#### 66 Front radiator grille trim incorrect for the vehicle

66 22 93 2068096/2 December 21, 2022. Supersedes Technical Service Bulletin Group 66 number 22-92 dated September 28, 2022, for reasons listed below.

Model(s)	Year	VIN Range	Vehicle-Specific Equipment
Q8, SQ8, and RS Q8	2023	000001 – 003082	Not Applicable

*Figure 1.* L1RR Platinum Grey radiator grille trim installed. LY9B Brilliant Black trim intended.

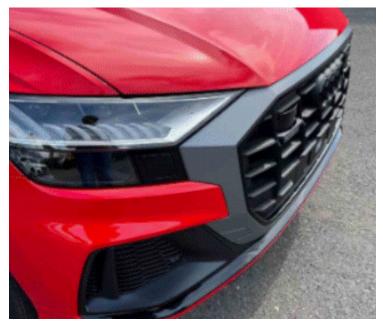
The trim that surrounds the front radiator grille installed in production is L1RR Platinum Grey instead of the intended LY9B Brilliant Black trim.

Figure 2 shows the correct configuration with a

LY9B Brilliant Black radiator trim.

Replace the radiator grille trim with the correct LY9B Brilliant Black trim.
